# 18-22 Haverstock Hill

## Planning Condition 03 - Materials - Responses

Project No: 864

Revision C | 26th October 2020

Proposed Window Head Detail Showing Brick Clad Lintel

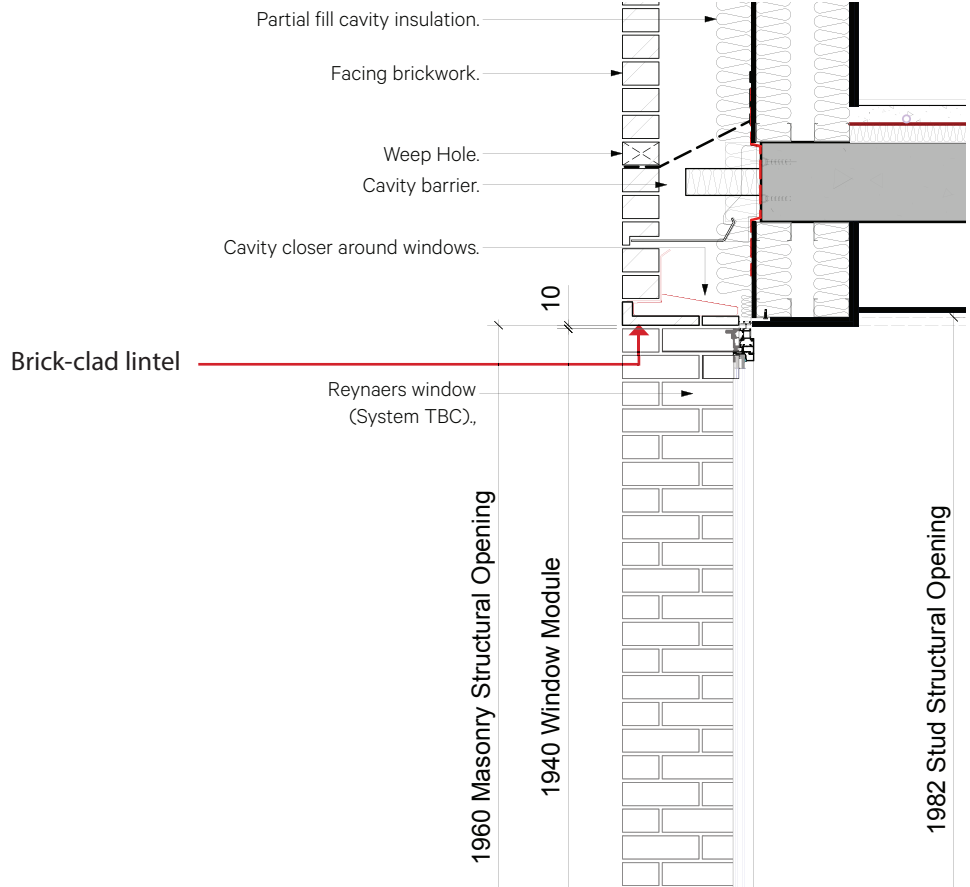
Planning Officer's Comment; 'Replacement of brick soffit with steel lintel (windows) and cement board (balconies)'

Our Client agrees to install brick-clad lintels above window and balcony openings to the front elevation as per the detail opposite.

Extract of Approved Drawing 13528-A-LXX-21-301 Showing Section Detail of Front Elevation Window

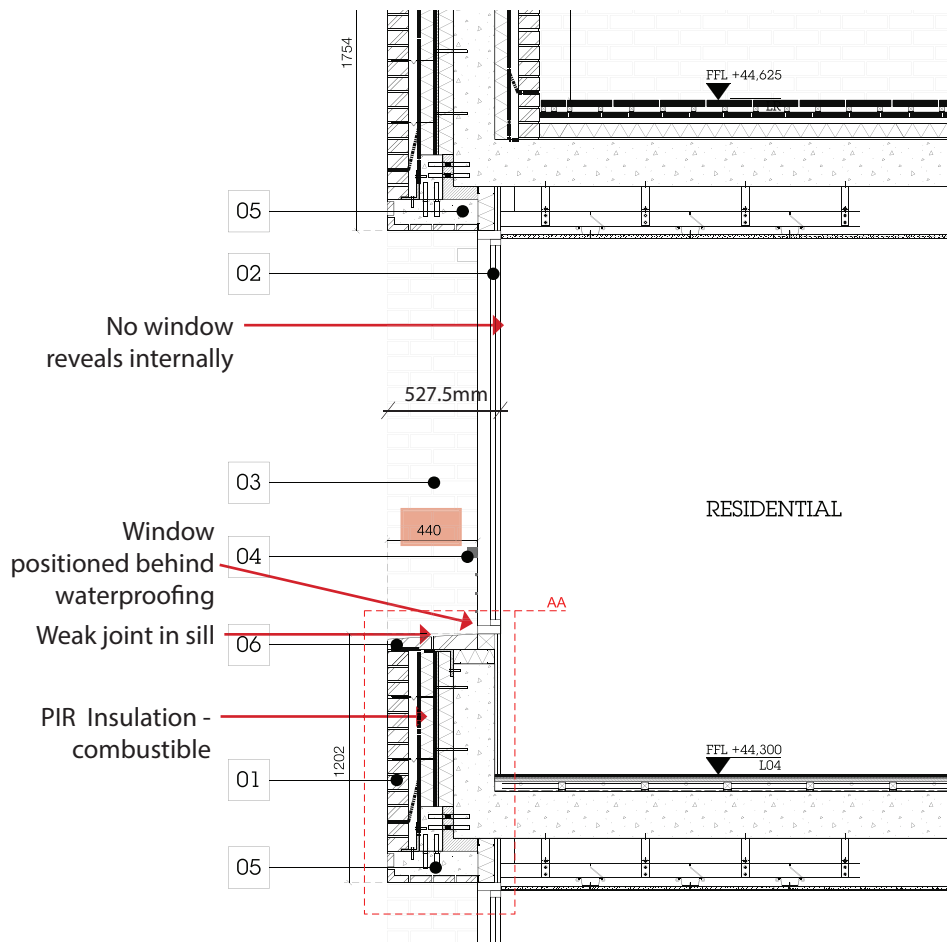
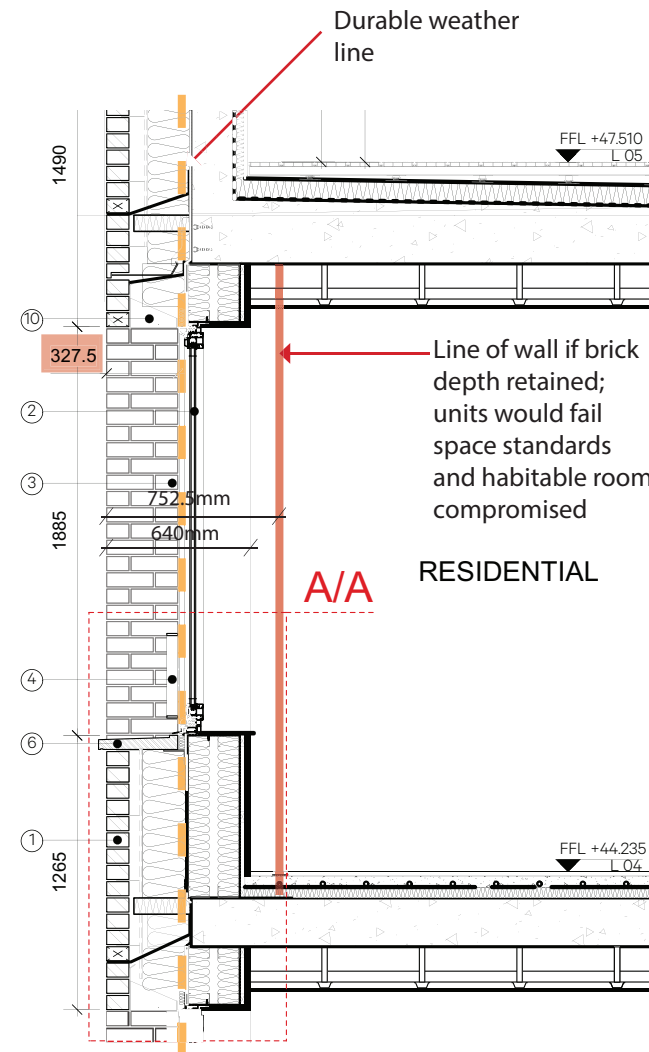
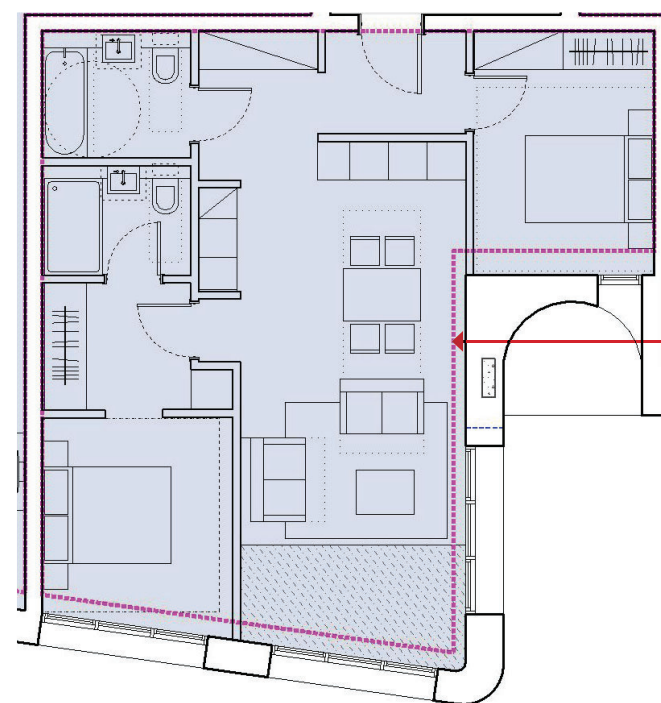
Planning Officer's Comment; 'Reduction of depth of window reveals (500mm in original permission)'

It should be noted that the original planning drawings were inconsistent; showing 440mm reveals to the front elevation in section as per the detail opposite (Approved Drawing No. 13528-A-LXX-21-300), with a 410mm reveal shown on the Approved Plans (Approved Drawing No. 13528-AP-01-00-101). Shallower full window reveals were indicated to all other elevations.

The current proposal is for 327.5mm (1.5 brick) reveals to the front elevation, and 215mm (1 brick) reveals to all other elevations. This change in depth between the front and side elevation is consistent with the original design intent.

Upon interrogation, it became clear that the Approved detail (far left) would not meet current Building Regulations:

Under current Fire Regulations informed by the tragic events at Grenfell Tower in 2017; only A1 non-combustible rated materials can be used in the external envelope of new tall buildings. This means that mineral wool insulation has to be used due to its non-combustible properties.

Noting the total thickness of 150mm insulation indicated in the Approved Drawing detail (it is assumed P&Co. proposed combustible PIR insulation), it is obvious that this would fall way short of achieving the required U-values using mineral wool insulation. The wall thickness would need to increase by at least another 300mm for this detail to work; resulting in many of the flats not achieving acceptable space standards. Please refer to plan opposite (bottom left) showing the effect on the wall thickness of increased insulation and increased window reveal depth; resulting in the loss of floor area making many of the flats sub-standard.

Furthermore, the Approved Drawing detail is extremely difficult to build and prone to failure as the window frame is set well behind the line of waterproofing which would eventually result in water ingress. The approved detail also has weaknesses in the form of thermal bridges which increases the risk of condensation.

As explained above, overly deep window reveals are not always practical as leaks are more prominent due to the complex nature of their construction. This can cause the details to deteriorate, resulting in unsightly staining and tarnishing of the building; this would be extremely noticeable due to the prominent location of the building and the use of white brick.

Purple dashed line indicates internal line of external wall if insulation increased by 300mm and window reveals increased to 500mm.

Roof Plan Highlighting Areas of Terrace

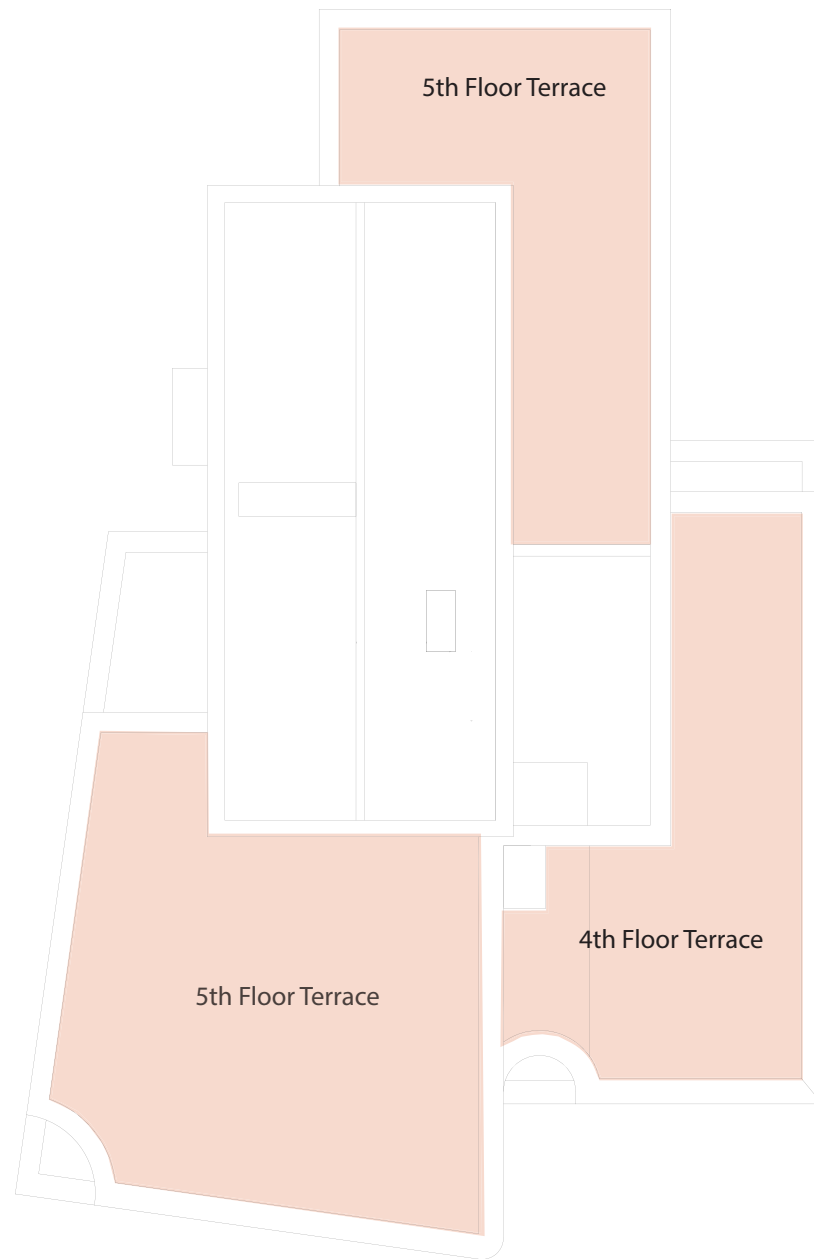
Planning Officer's Comment; *'Replacement of timber decking with aluminum'*

It is now mandatory that all balconies and terraces located within 1m of a relevant boundary or situated more than 18m above ground level, must have non-combustible decking. Therefore timber decking cannot be used in this development.

The specified aluminum decking is non-combustible, more robust, durable and requires less maintenance than timber alternatives, meaning that it will last and look better for longer.

The selection adheres to regulations and matches the overall material palette of the scheme (white brickwork, bronze metal, rich brown zinc cladding).

It is also worth noting that due to the height of the terraces and concealed nature of the balconies, views of them will be very limited from outside of the site.

Extract of Approved Drawing Front Elevation Showing Green Scallop Ceramic Tiles to Top Setback

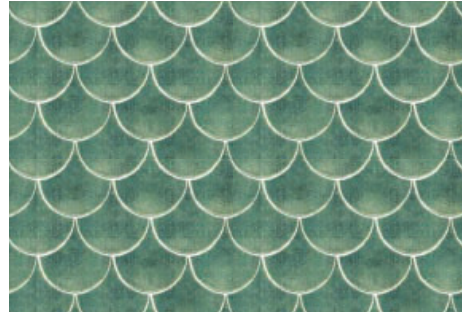
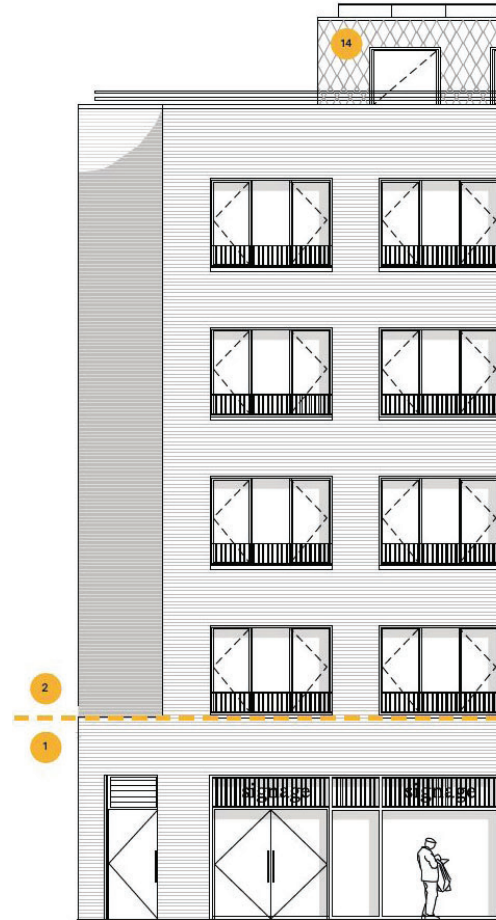
Planning Officer's Comment; *'Substitution of ceramic cladding on the set back roof storey with zinc cladding'*

Following design reviews it was agreed that the zinc shingles would form part of a more controlled palette of materials. Furthermore, if they were matched to the bronze colour of the window frames, then this would create a more coherent scheme.

The proposed zinc cladding is a high quality material that responds to and enhances the conservation style buildings in the immediate area. Please see examples; bottom left.

It is also worth noting that the green scallop shaped ceramic tile specified in the D&A Statement is an internal bathroom tile and inappropriate for use as external cladding. If used, the scale of the scallop would not match the approved drawings; the pattern would not be legible from more than a few meters away.

The tiles would need to be massively scaled-up to match the aesthetic in the D&A statement. Fixing large format tiles at height (either by adhesive or hanging) is extremely dangerous as they are affected by the elements and can become loose, endangering building users and passers-by below.

The zinc cladding in a patterned tile format, responds to the condition wording, offers a more robust, weather tight solution that ties in with the overall material palette.

Extract of Approved Drawing 13528-A-LXX-21-302 Showing Horizontal Balustrade Arrangement

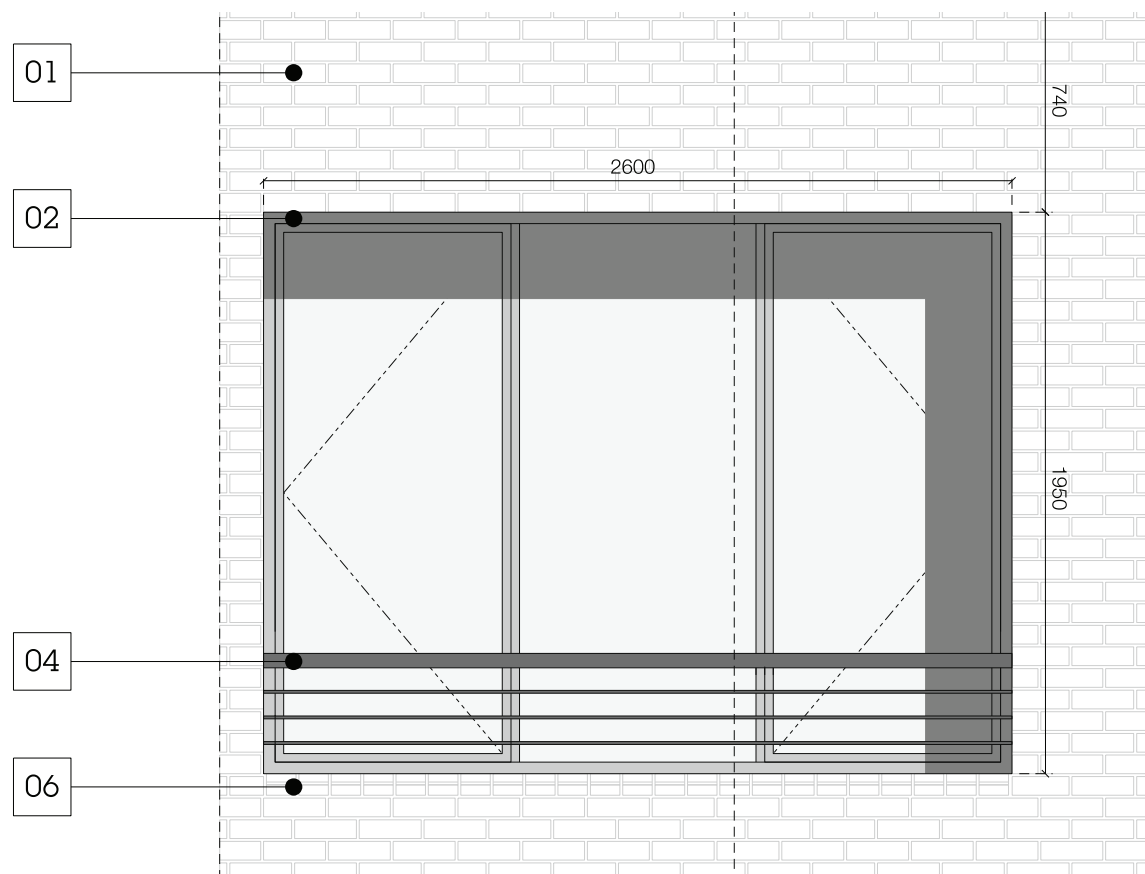
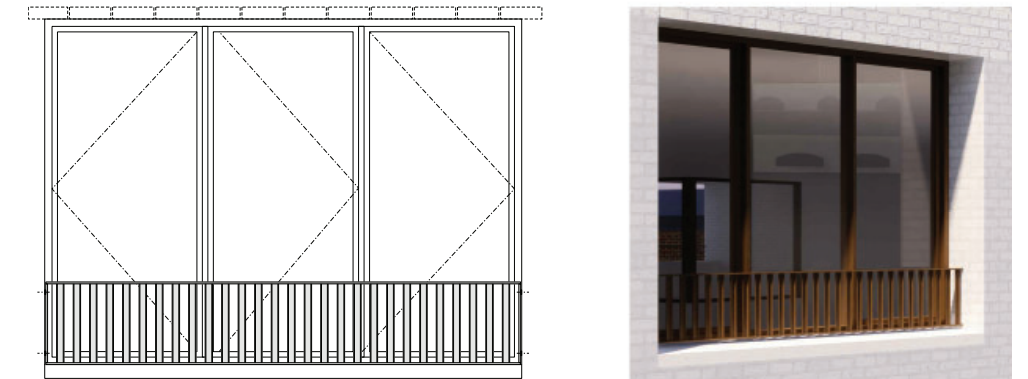
Planning Officer's Comment; 'Balustrade to windows and balconies with a vertical railing pattern - original design intent emphasises horizontality of the building'

The vertical railing design (detailed below) has been developed to provide a safer less climbable solution than the horizontal design opposite as the railings commence below 1100mm. We would like to request that this design is considered by the Council.

However, if it is deemed not acceptable, our Client agrees to revert to the horizontal railing design as described in the Approved Drawing 13528-A-LXX-21-302.

Approved Drawing No. 13528-A-LXX-21-300 - Parapet Detail

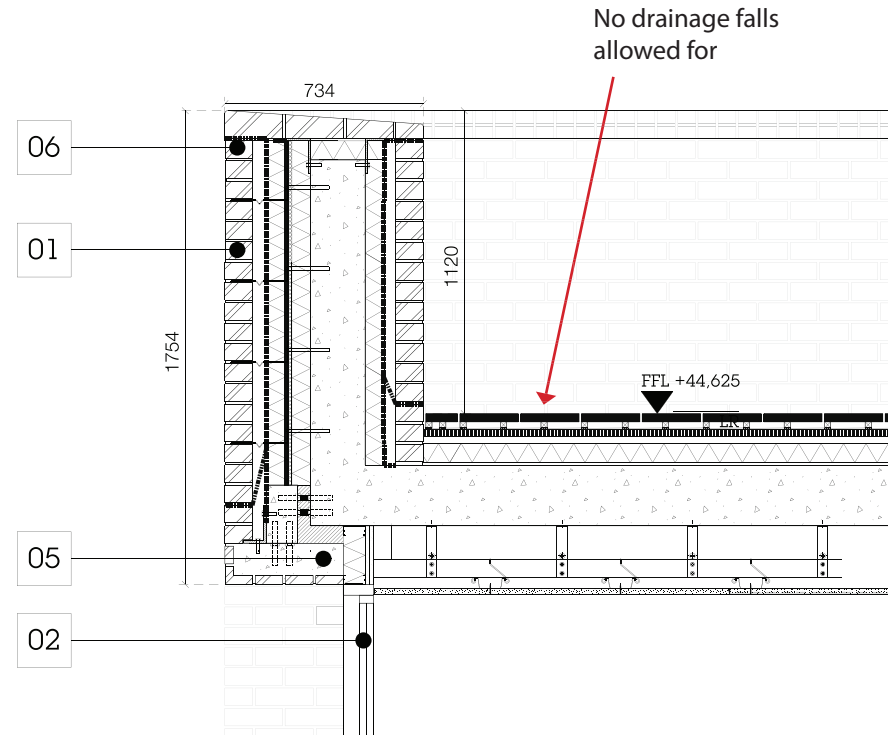
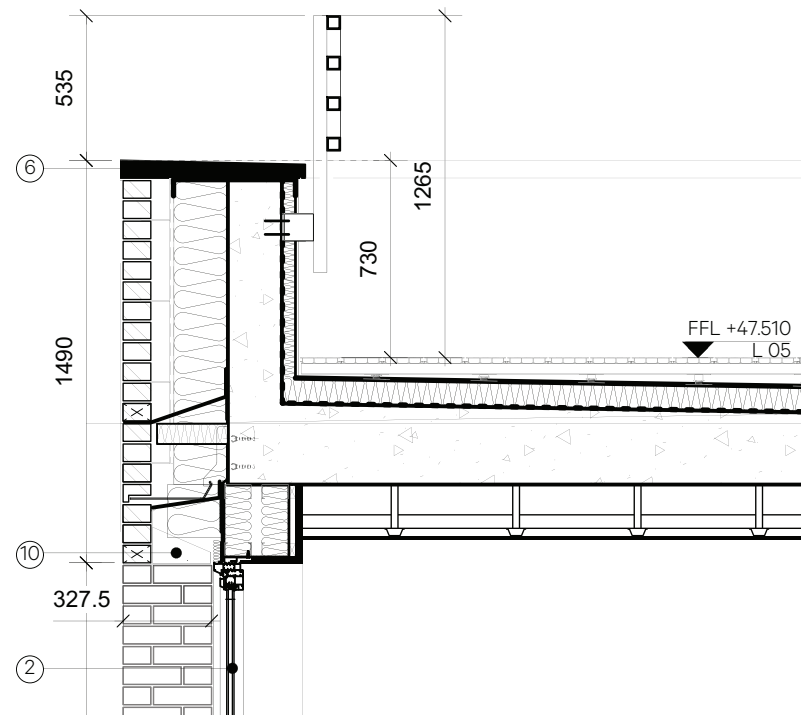
Planning Officer's Comment; *'Highly visible parapet railings'*

The Approved Drawing parapet detail shown opposite, indicatively shows roof build-ups, but has not allowed for any gradients in order to drain the terraces. Due to the large terrace areas, this will add a significant depth to the stated roof build-up, which in-turn would cause the parapet height to increase.

The parapet detail (bottom left) has been developed and drainage falls included resulting in the overall depths being increased to meet current Building Regulations.

The result has been that the FFL to the terrace levels has increased, which would have also resulted in the parapet also being raised to maintain the required 1100mm barrier height. On review this detracted from the overall proportions of the street elevations.

Approved Height of Glazed Brick Aligned with First Floor Window Head

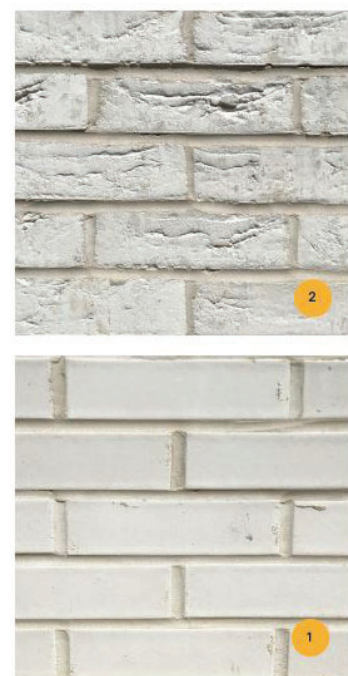
Planning Officer's Comment; 'the glazed bricks need to be taken up to first floor as in the original scheme - they are shown only at ground floor'

Our Client agrees to raising the height of glazed bricks back to the consented level as shown in the image opposite.

We would however, like to request that Camden reconsider as the lower height provides a cleaner datum which aligns with both the window sills and the small parapet walls at first floor level.

Raising the height of the glazed brickwork creates an awkward junction to the left hand corner where the glazed brick follows the quarter curve and then abruptly stops. This is a prominent corner and this awkward junction will be extremely visible.
